PLANNING COMMISSION AGENDA

PUBLIC HEARING: Variance to increase the maximum front yard building setback; and Site Plan Review for Dayton Assisted Living, 136XX Balsam Lane N., PID: 14-120-22-41-0005

To:	Jon Sevald, Planning	From:	Jason Quisberg, Engineering Nick Findley, Engineering Ben Otto, Engineering
Project:	Dayton Assisted Living	Date:	4/30/2026

1 UNDERGROUND STORM WATER DETENTION SYSTEM ELEV

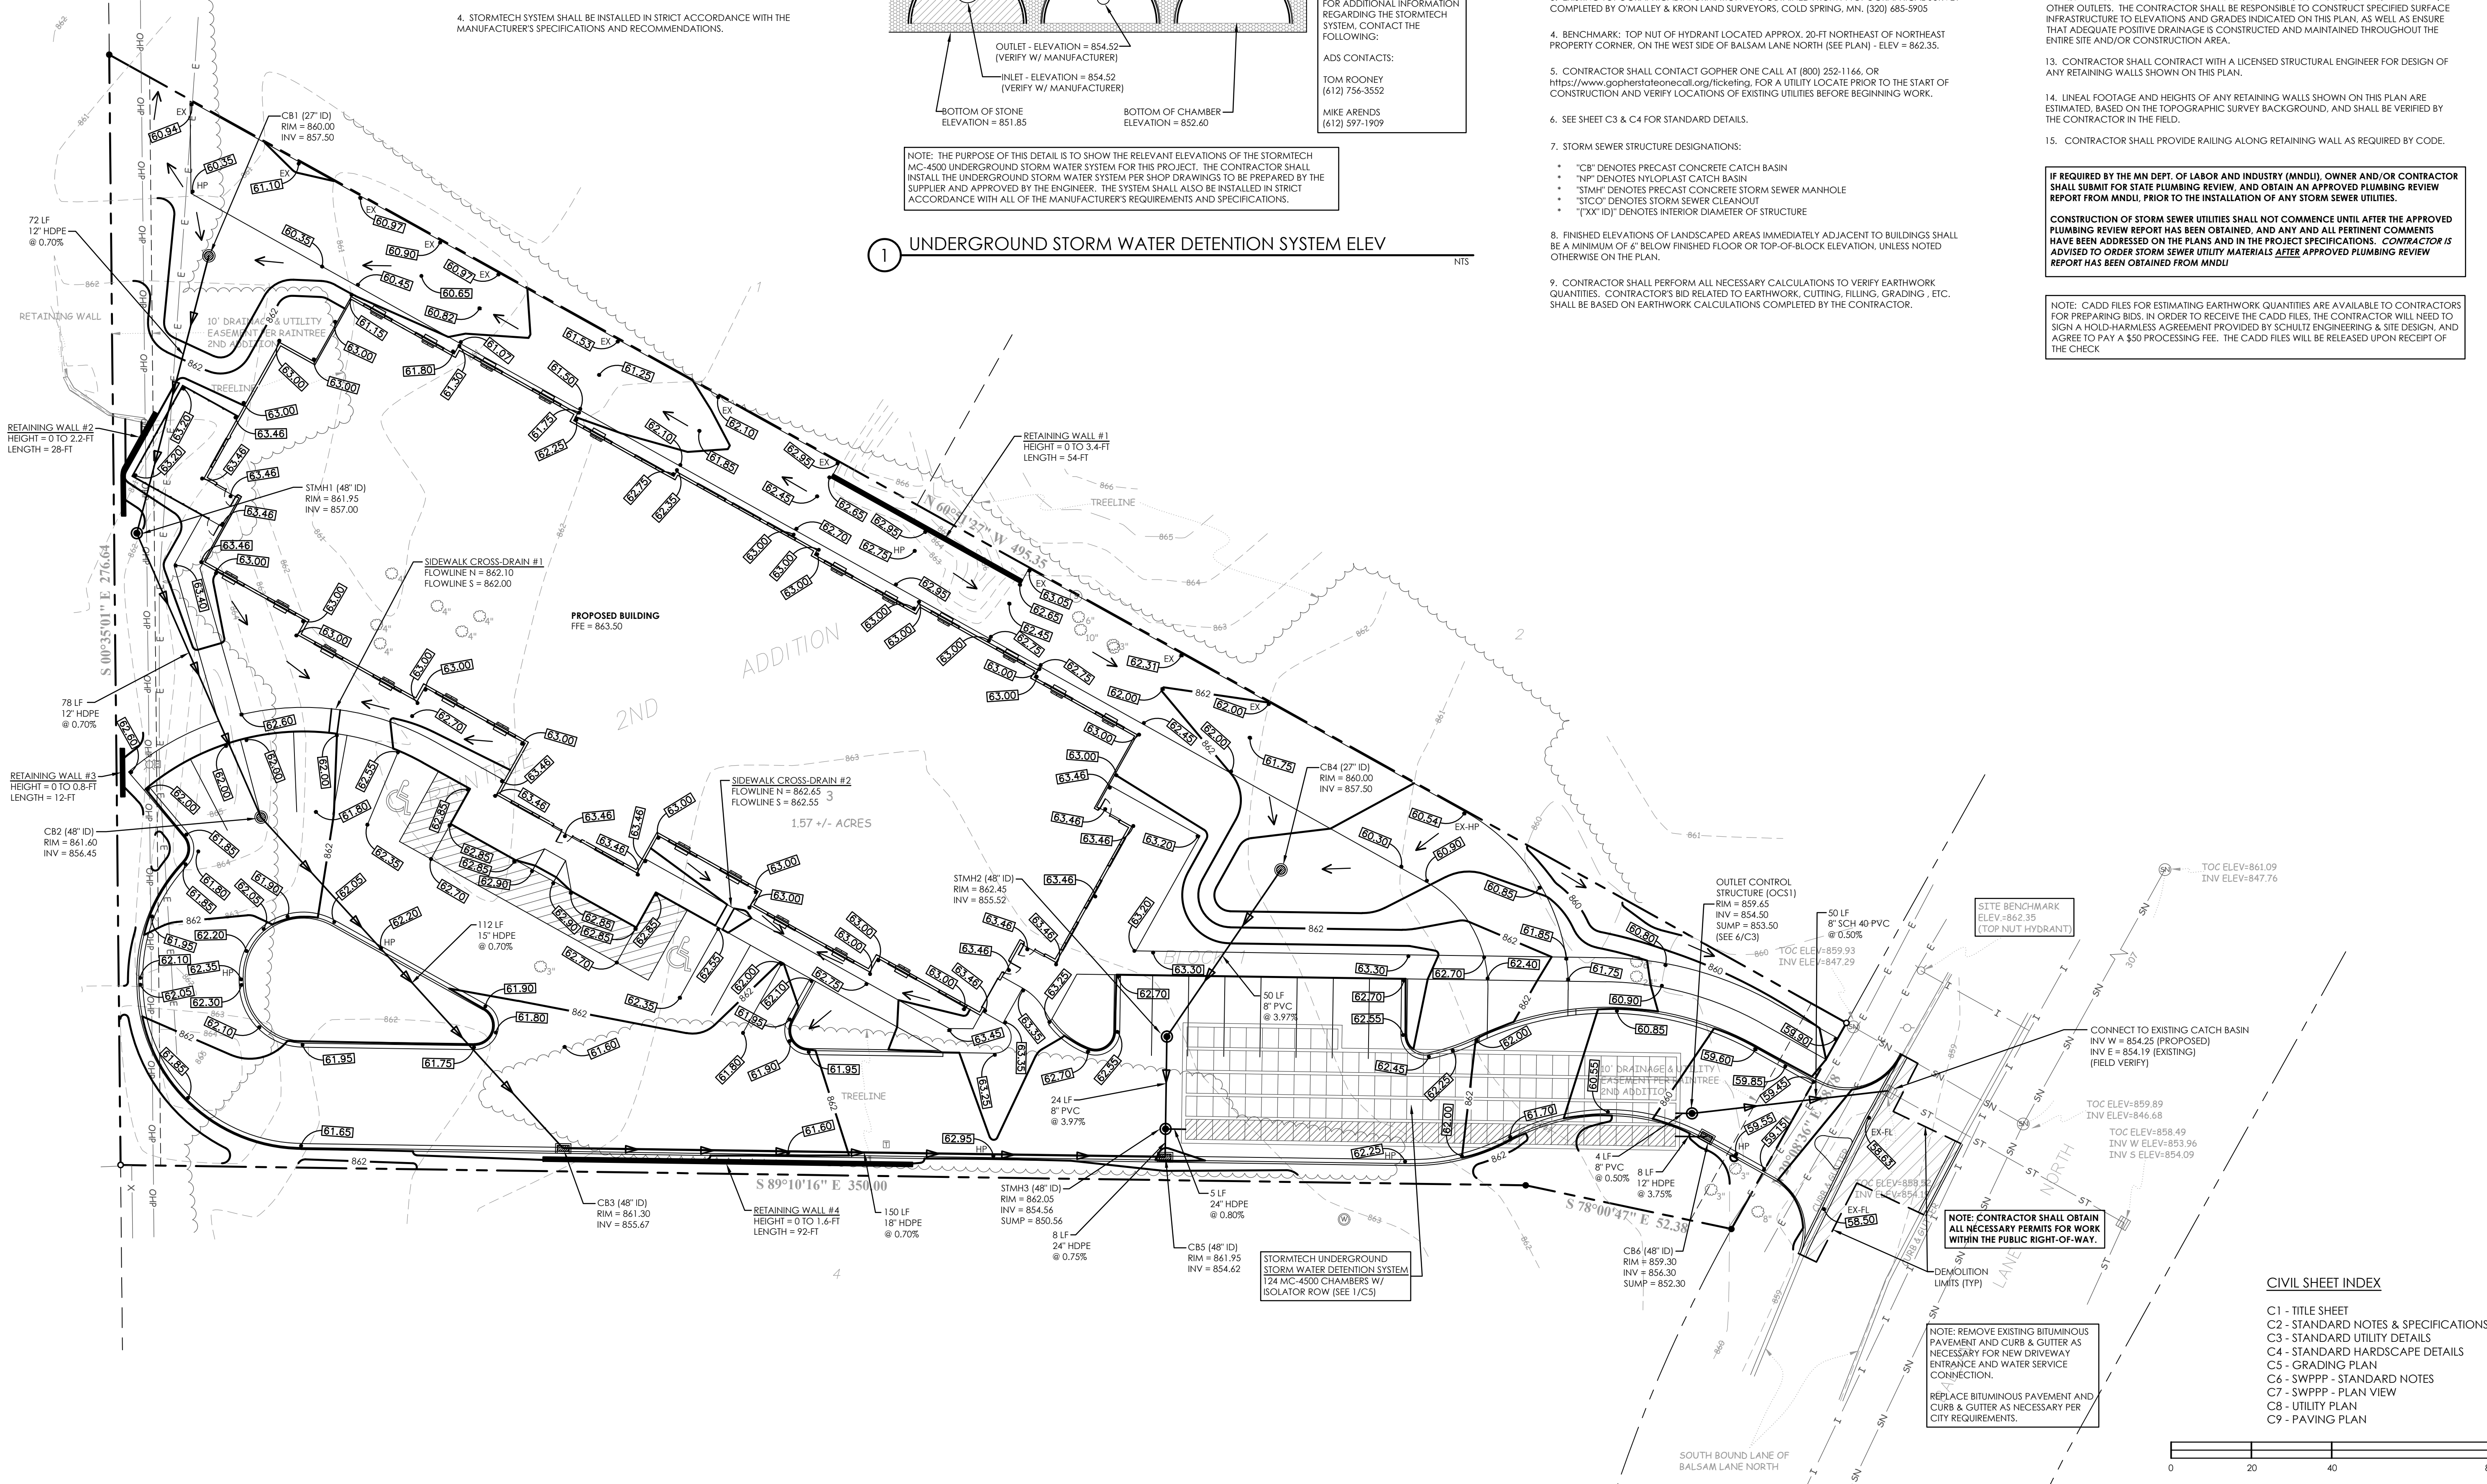
25. Update OCS 1 detail on sheet C3 to match information on sheet C5. Update plan sheets to be consistent throughout.
26. Update Device #3 for pond node MC-4500 in the proposed HydroCAD model to model a broad crested weir instead of a sharp crested weir.

28. Some of the elevation information listed under the "Elevations" annotation in Detail 1 - "Underground Storm Water Detention System Elev" on sheet C5 do not appear to match the detail depicted. Update elevation information to ensure consistency throughout.

Project: 26006
 Scale: 1"=20'
 Sheet: GRADING PLAN
 C5 of 9

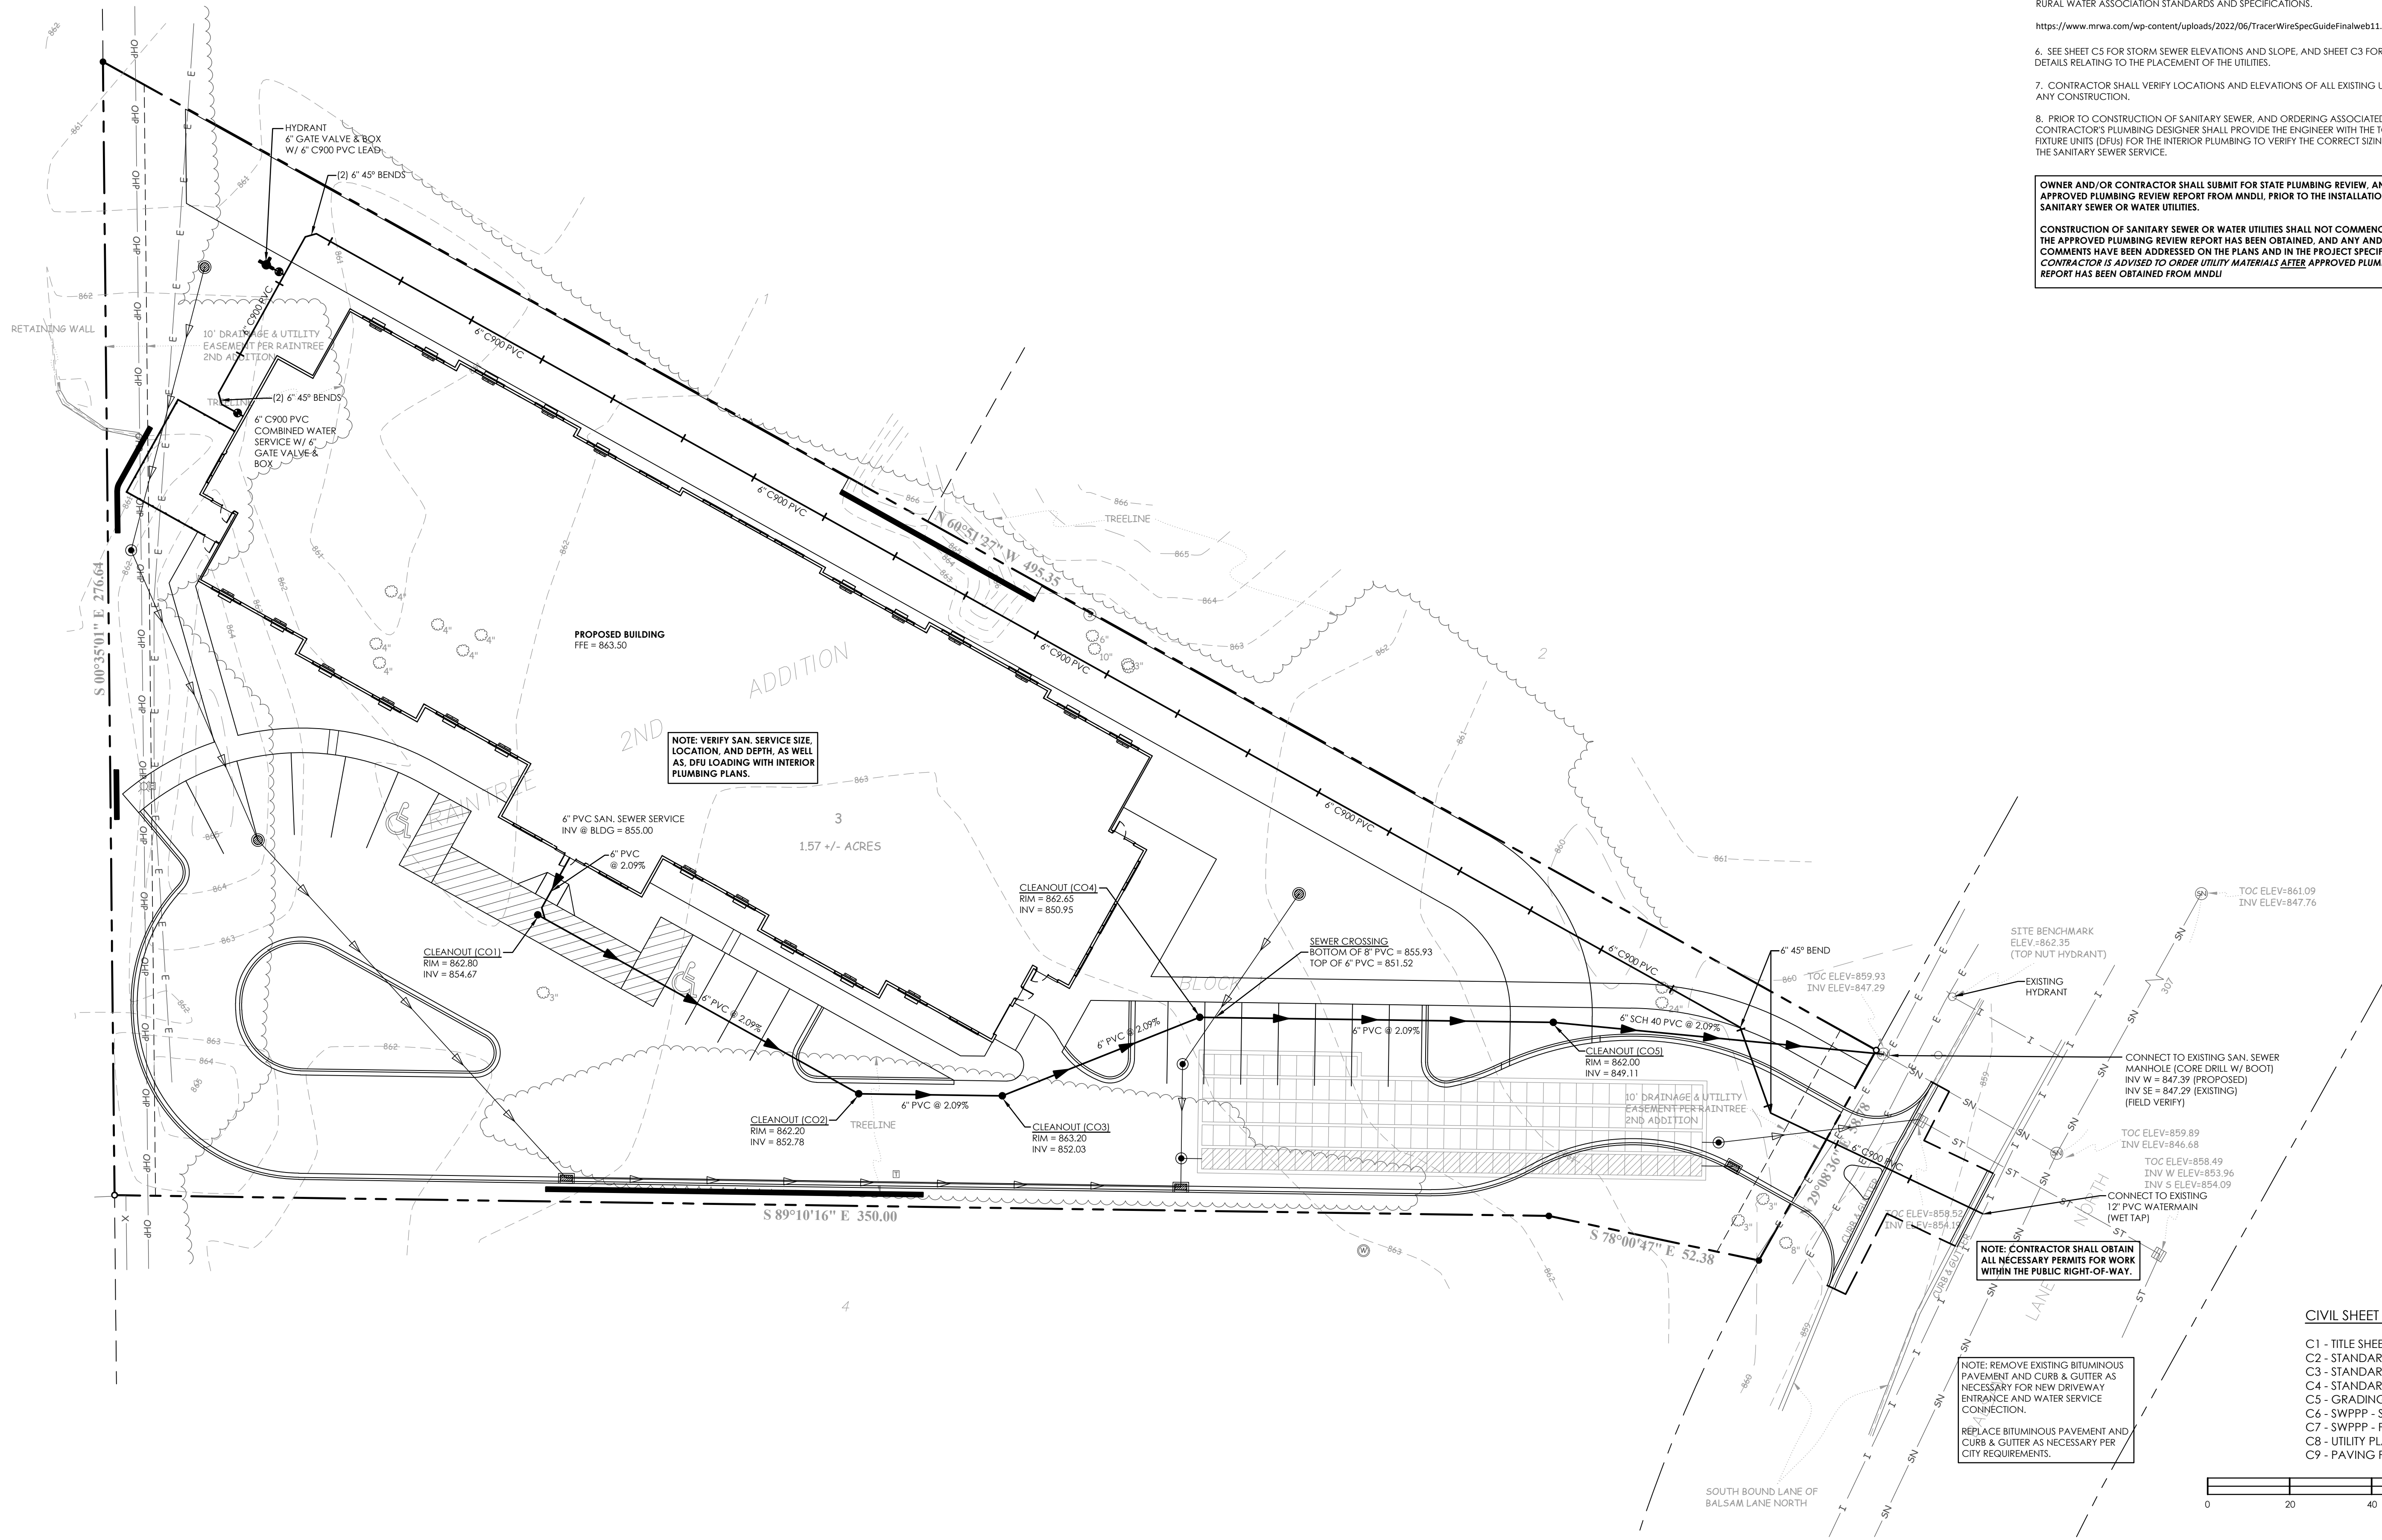
16. Provide top and bottom retaining wall elevations at tie ins and slope changes for all proposed retaining walls.
17. The existing storm sewer structure located in the proposed entrance currently has a R-3067 casting. A drive-over casting will need to installed with the proposed entrance.

34. Per City of Dayton standards drainage swales are required to be a minimum of 2%.
35. Provide spot elevations for the swale running along the northeast property line to ensure drainage is not trapped and the 2% requirement is met.
